CALVERT CLIFFS
NUCLEAR POWER PLANT

NRC 11-001

SUBJECT: Calvert Cliffs Nuclear Power Plant
Unit Nos. 1 & 2; Docket Nos. 50-317 & 50-318
Supplement to the License Amendment Request: Transition from Westinghouse
Nuclear Fuel to AREVA Nuclear Fuel

NON-PROPRIETARY SUPPLEMENT TO LICENSE AMENDMENT

Figure 26-1, Doppler Coefficient versus Burnup

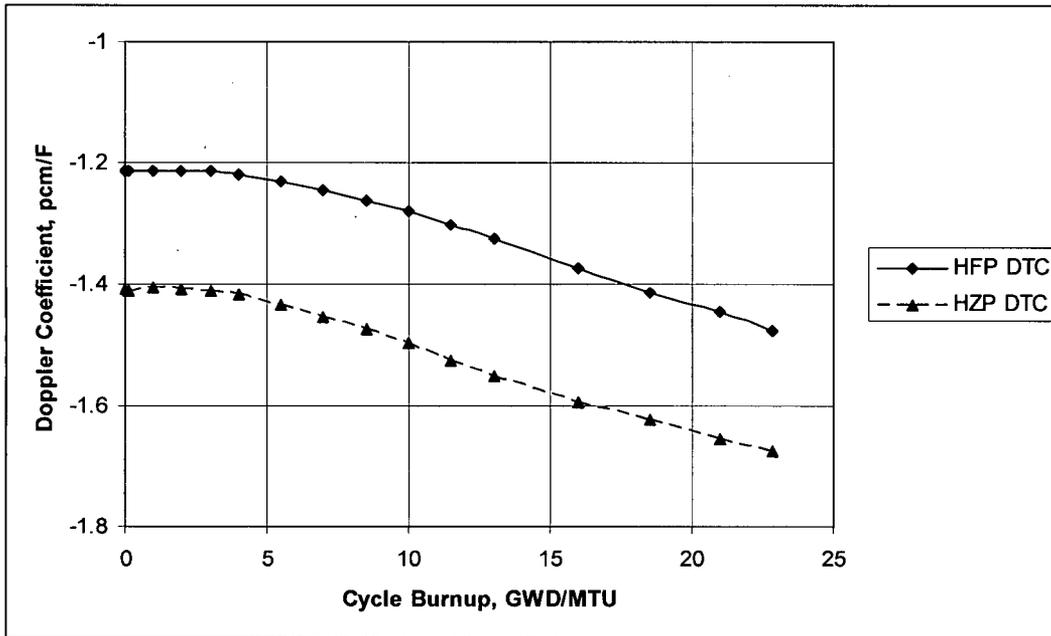
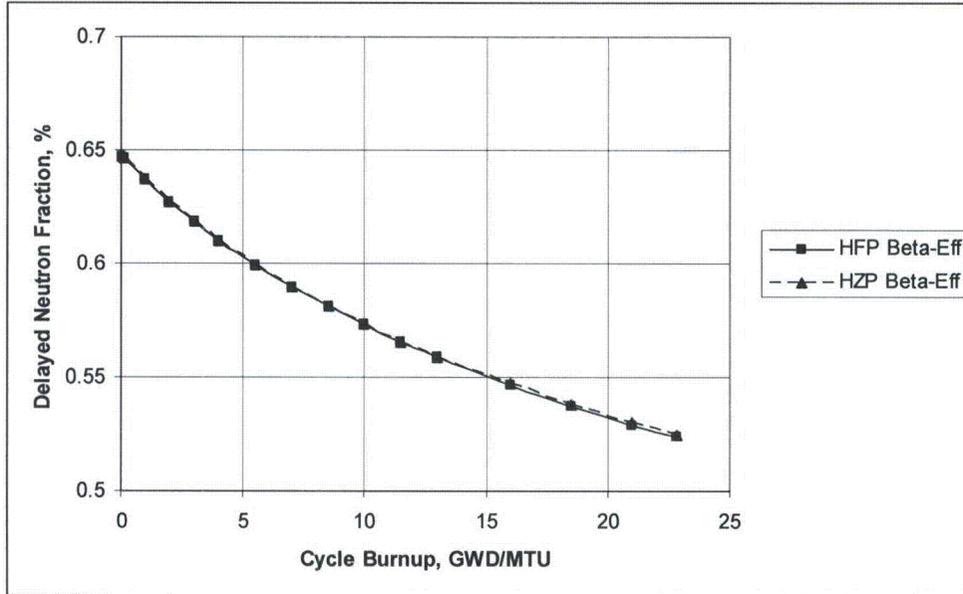
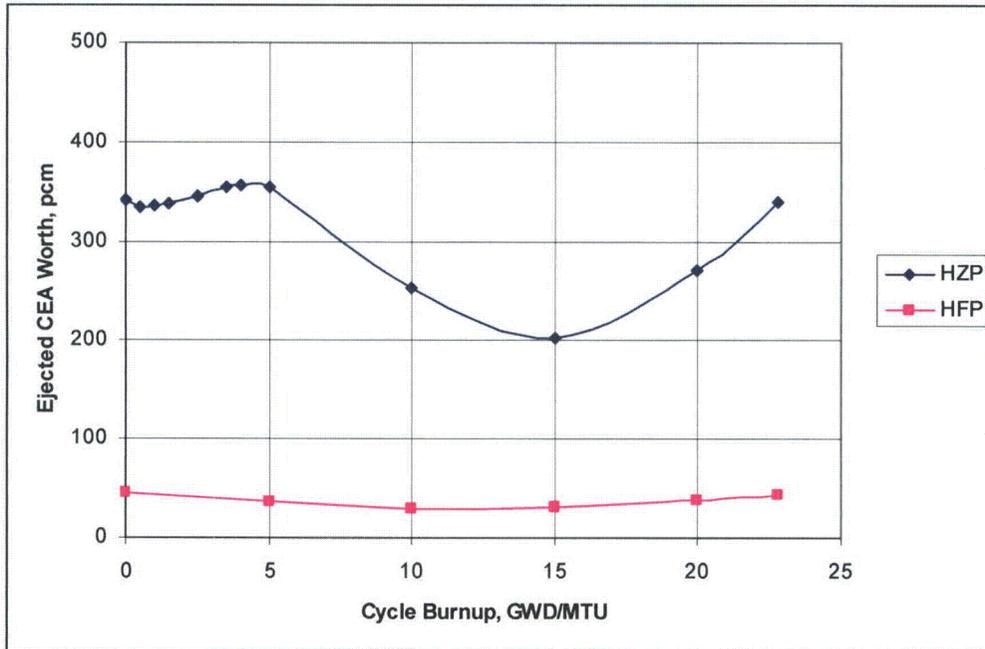
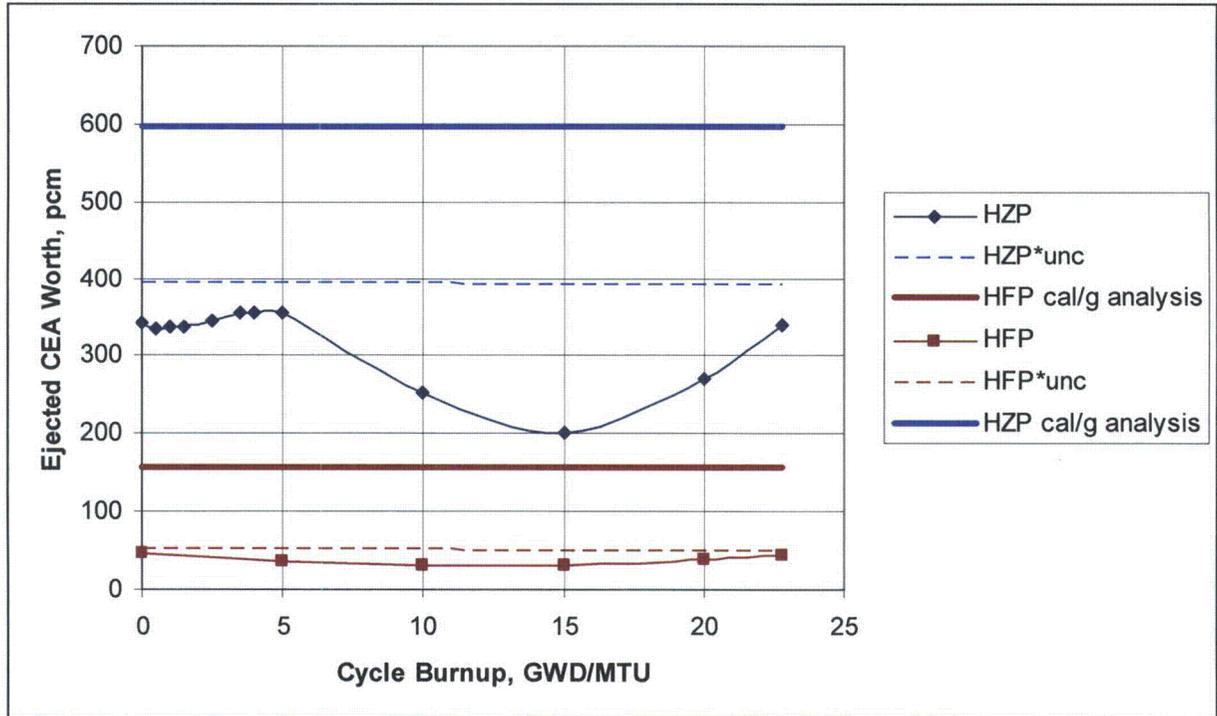
In RAI #14, the staff requested an explanation of the use of BOC and EOC physics parameters. The response (provided in RAI #3) was insufficient to justify analyzing only these two extreme cases. At EOC conditions, FTC is most negative (turns event around) and B_{eff} is smallest (promotes power excursion). These parameters act to offset each other, so the limiting scenario may be at another BU point where FTC is not so negative. This is probably the reason why the UFSAR AOR combines limiting parameters, regardless of exposure dependence.

The cycle dependence of the Doppler coefficient, effective delayed neutron fraction (β), and ejected CEA worth are shown in Figures 26-1 through 26-3. After ~ 5 GWd/MTU, the Doppler coefficient and the β are nearly linear with cycle burnup. The Doppler coefficient remains nearly constant for fuel burnups less than 5 GWd/MTU. The ejected CEA worth is the driving parameter for this event and the beginning of cycle and end of cycle endpoints reasonably bound its behavior over the whole cycle. Prior to obtaining the ejected CEA worth (cal/g), the uncertainty is applied to the endpoint values for the beginning of cycle and the end of cycle, and the CEA worth is further increased to a minimum CEA worth analyzed for the cal/g that conservatively bounds the data as shown in Figure 26-4.

A sensitivity calculation is performed to determine whether this conservatism is adequate to cover the variation in Doppler coefficient and β . The moderator temperature coefficient is assumed to be zero for all calculations so that the end of cycle case contains more conservatism than the beginning of cycle case. In order to bound the beginning of cycle case, a β of 0.6% is selected to bound the behavior from 0-5 GWd/MTU. The ejected CEA worth (cal/g) is re-calculated with a β of 0.6% at hot full power and hot zero power, and the changes in ejected CEA worth (cal/g) at hot zero power and hot full power are +2.2 and +2.7 cal/g, respectively. The change in ejected CEA worth that would yield the same cal/g change at hot zero power and hot full power are 12.0 and 53.5 pcm, respectively. As shown in Figure 26-4, these values are small compared to the conservatism already included in the analyzed CEA worth. Hence, the evaluation of the beginning of cycle and the end of cycle endpoints remains bounding.
